**Re: **Response to Comments, Voluntary Remediation
Program Data Gaps Work Plan, Freeport-McMoran
Sierrita Mine Green Valley, Arizona; Site Code: 100073-03****

VOLUNTARY REMEDIATION PROGRAM DATA GAPS WORKPLAN

Figure E1- Alluvial or Bedrock Monitoring Well Construction (Depth ~0-200 feet)

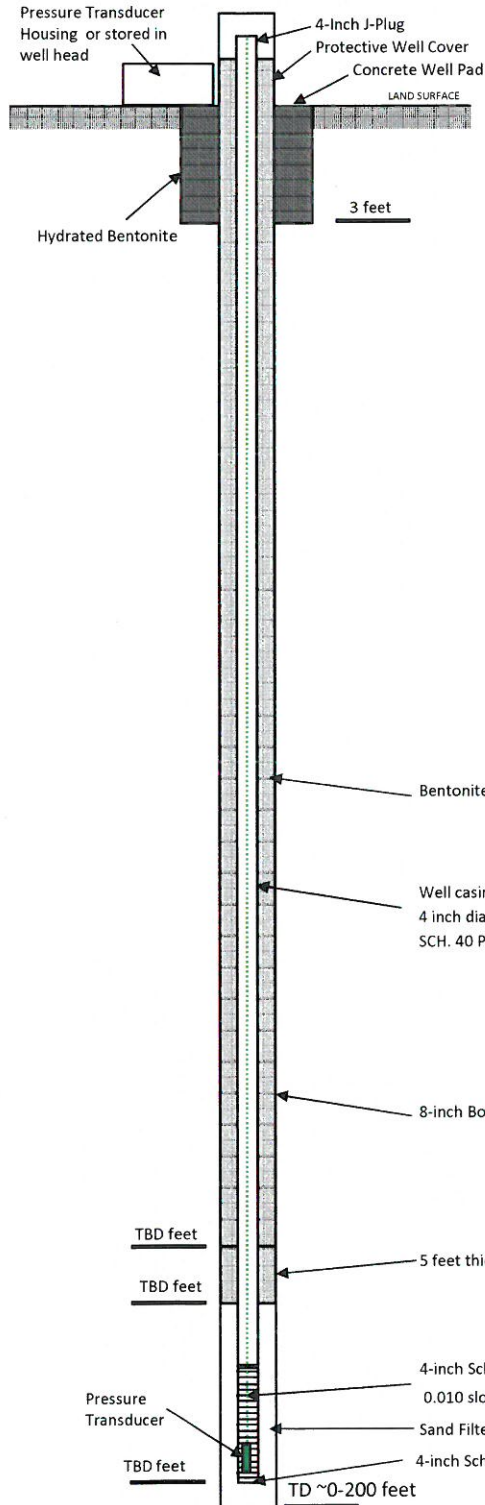
Please provide a detailed description of the proposed construction of the bedrock groundwater monitoring wells to demonstrate that the screened intervals will be completely sealed from the overlying alluvium unit.

The proposed well construction details and well construction diagrams, relative to the depth of installation, are presented in Attachment 1. The proposed well construction details have been revised based on a review of the most recent groundwater monitoring data. To ensure that the screen intervals will be sealed from the alluvium unit where alluvial materials are present at a proposed location overlying a target bedrock unit, the well advancement and installation procedures will include:

- During advancement of boreholes into bedrock with saturated alluvial materials overlying the bedrock, it is anticipated that a casing advance system will be used. This will seal the bedrock unit from the overlying alluvial unit during advancement. If a casing advance drilling method is not used then a conductor casing will be placed against the alluvial materials, extending approximately 2 to 3 feet into the bedrock unit. The conductor casing will be grouted in place prior to additional advancement into the bedrock unit.

- For well construction, the screen interval of each bedrock groundwater monitoring well and filter pack will only be placed adjacent to the target bedrock formation and will not extend upwards into overlying alluvial materials. A bentonite seal of approximately 5 feet of 3/8 inch chip bentonite will be placed on top of the installed monitoring well filter pack, followed by a 3% to 5% bentonite / 95% to 97% Portland cement grout to the surface. The chip bentonite or cement grout will extend across the bedrock-alluvium contact.

**PROPOSED WELL LOCATIONS AND
THIRD AND FOURTH QUARTER 2013
POTENTIOMETRIC SURFACE MAP**

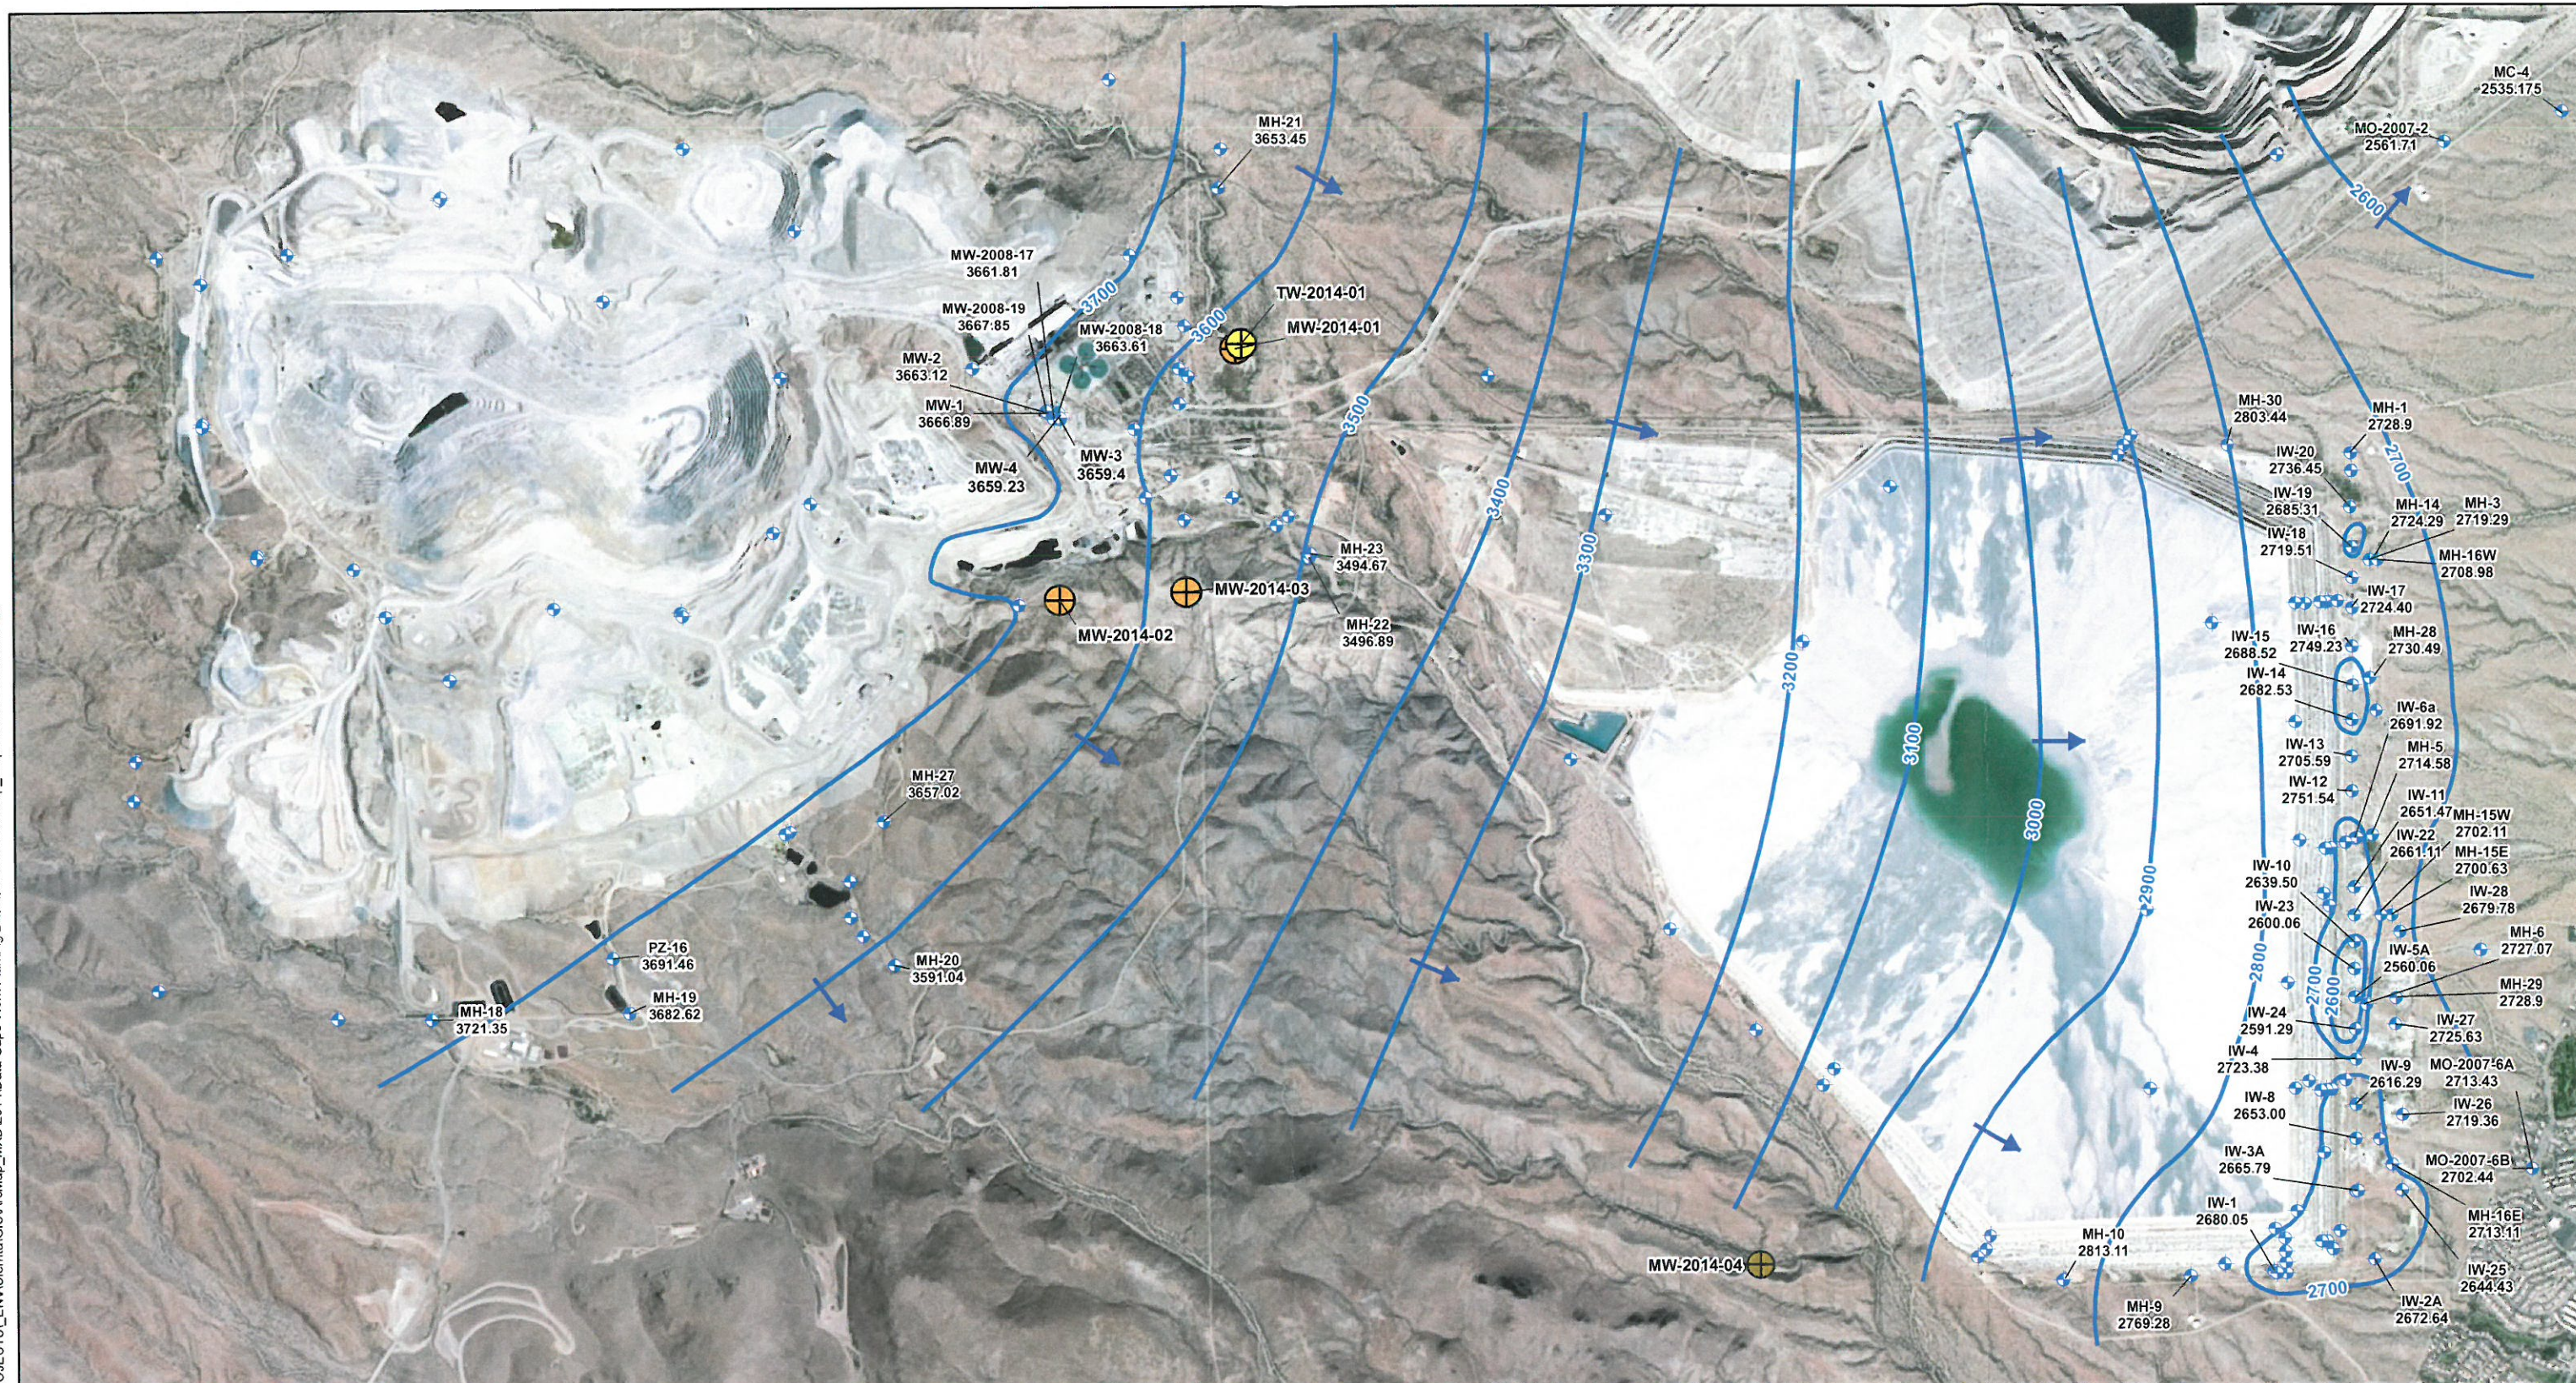
Please provide the latest potentiometric map to facilitate the demonstration that the proposed groundwater monitor wells are appropriately located.

Potentiometric maps for the most recently sampled wet and dry seasons, which were collected in the third and fourth quarters of 2013 and first and second quarters of 2014, respectively, are presented in Figures 1 and 2. A comparison of the wet and dry season water levels indicates a change in head of approximately 1 to 5 feet might be anticipated seasonally for the areas where new monitoring wells have been proposed. The dry season groundwater elevations have been used to anticipate the proposed monitoring well installation depths and screen intervals, which are provided in Table 1. Additionally, proposed well construction diagrams are presented for wells installed up to 200 feet in depth and then for wells to be installed from depths between 200 feet and 600 feet. Installations beyond 600 feet are not anticipated. This information demonstrates that each of the proposed monitoring wells are appropriately constructed for the requirements proposed in the Work Plan.
